# Economic and Social Council

### Working Party on Passive Safety

#### Fifty-first session

## Report of the Working Party on Passive Safety on its fifty-first session

Figure 7

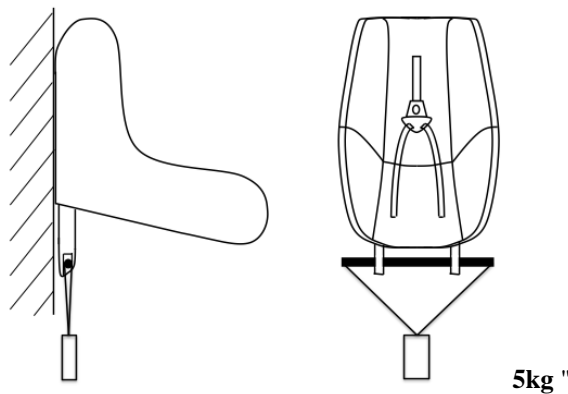
"8.2.9. **The complete seat, or the component fitted with ISOFIX attachments (e.g. ISOFIX base) if it has a release button, is attached rigidly to a test rig in such a way that ISOFIX connectors are vertically aligned as shown in Figure 7. A 6 mm diameter bar, 350 mm long, shall be attached to the ISOFIX connectors. A mass of 5 kg shall be attached to the extremities of the bar.**

Figure 1

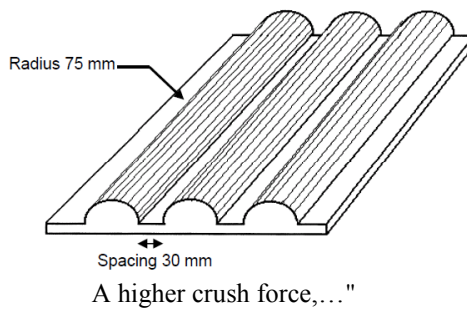
The Tested-Device shall be crushed between a resistance and a crush plate as described in figure 1 with a force of at least 100 kN, ... but not exceeding 10 s.

**Dimension of the crush plate:  
600 mm x 600 mm or smaller**
